Subject: Notification Concerning Xomox Tufline Sleeved Plug Valves

Subject: Notification Concerning Xomox Tufline Sleeved Plug Valves

XOMOX-TUFLINE SLEEVED PLUG VALVE TOP SEAL

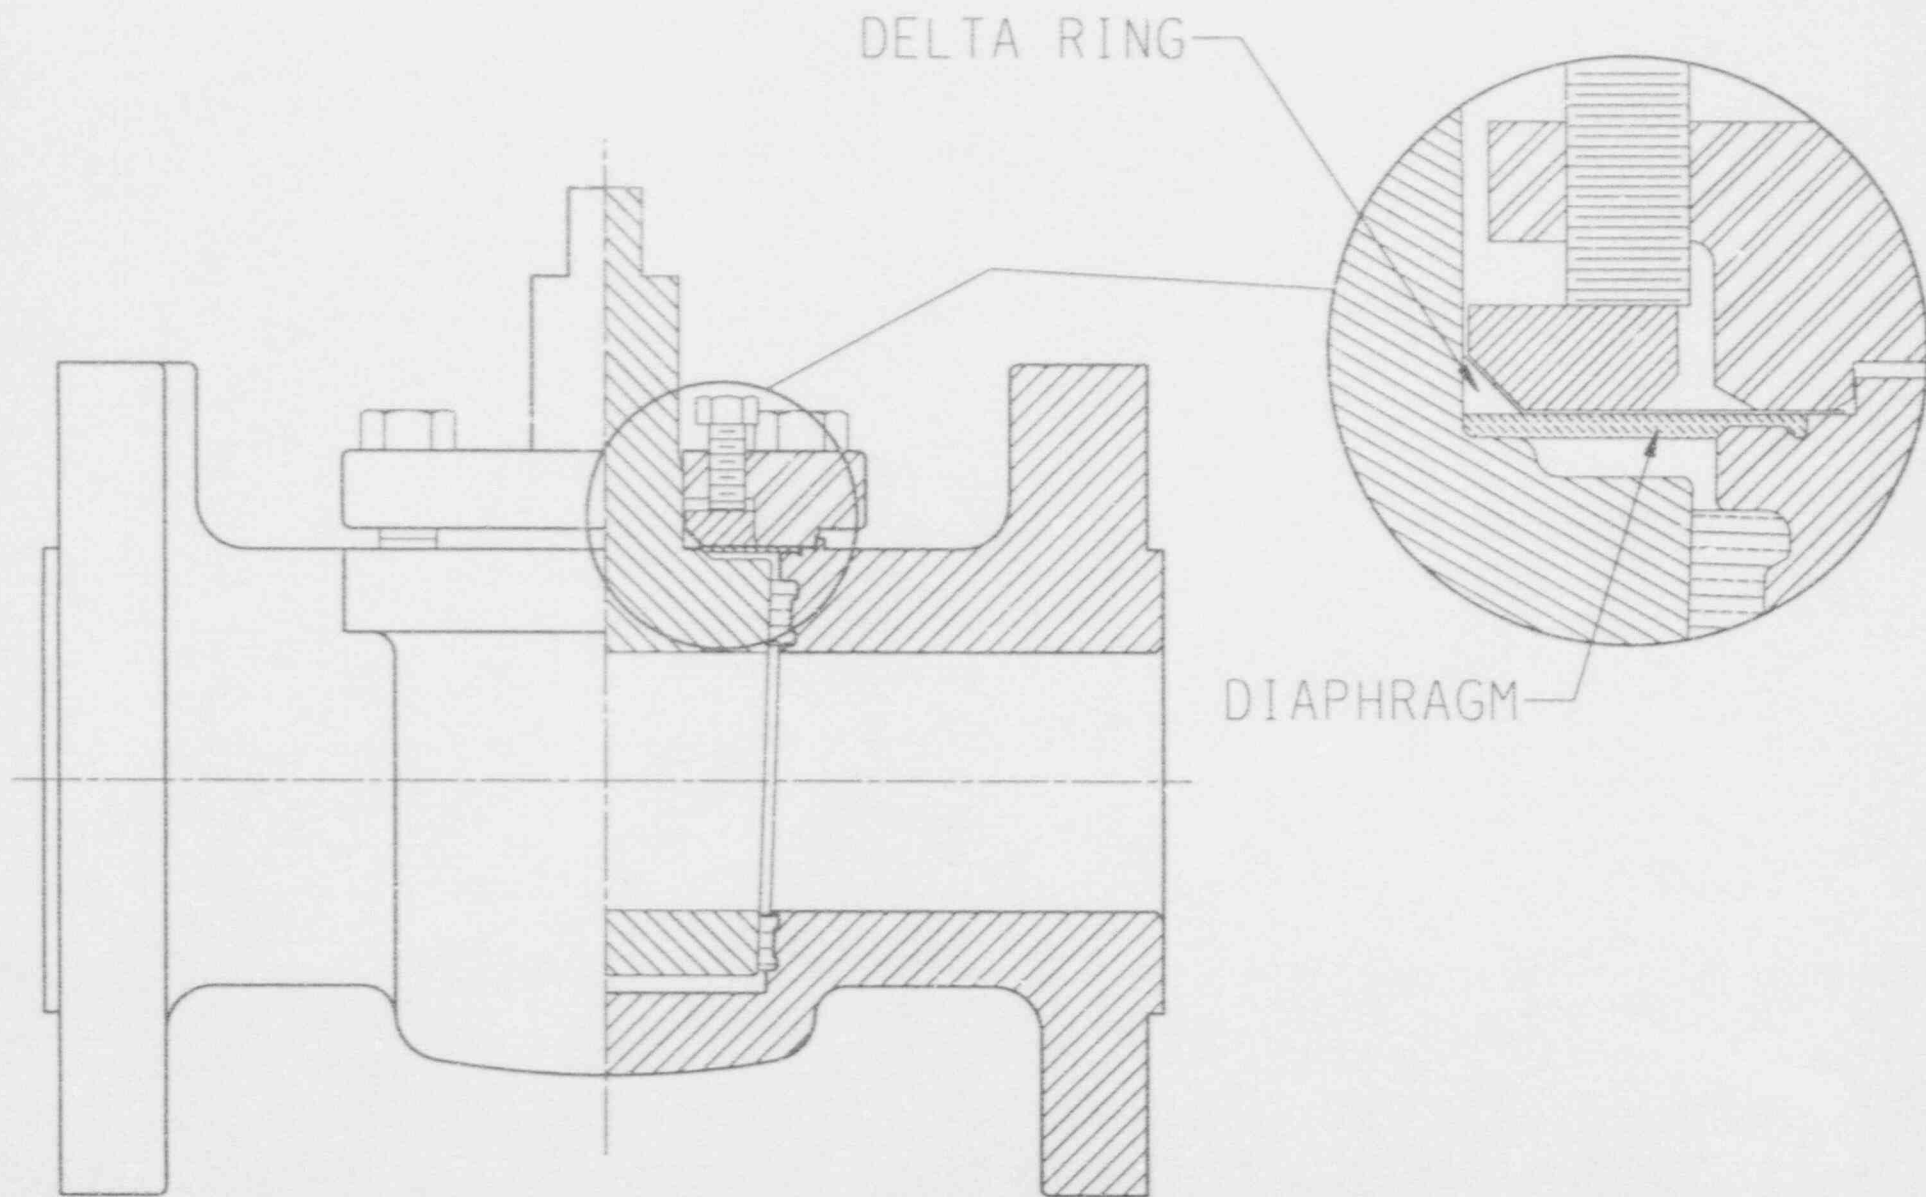
Nuclear service valves were generally supplied with Ultra High Molecular Weight Polyethylene (UHMWPE) seals. We have determined, however, that some valves were shipped with Low Density Polyethylene (LDPE) seals. The two materials look very much alike. To ensure you have the correct material in your valves, we will provide replacement seals of UHMWPE to all customers with Tufline valves. These replacements are being procured and will be available for immediate shipment shortly. In the meantime, because we are unable to assess the impact this may have on your particular application of this product, we are notifying you of the possible deviation in order that you may conduct any evaluation you deem appropriate in accordance with the terms of 10CFR Part 21. We are also notifying the NRC of this situation by letter, a copy of which is enclosed for your information.

1. The valves affected are Xomox Tuflin sleeved plug valve models: 067,066,0366, 0666, 166, 136, 1366, 1666, 096, 0396, 0696, 0367, 0667, 037, 0337, 0637, 9037.
2. Seals on these identified valves may have reduced temperature capability and possibly reduced radiation resistance if they are LDPE material rather than UHMWPE. The valve seals may shrink and leak if subjected to conditions exceeding the limits of the LDPE material. A diagram is enclosed to help you identify the seal in question. To date, we have received no reports from customers of any actual leakage or other application problems.

Xomox recommends that customers thoroughly review the identified products delivered to their plant sites as they relate to this information. The customer then should make a determination of the safety considerations for their specific application. After your review please contact Jamie Davidson, (513) 745-6017 to arrange shipment of replacement seals.
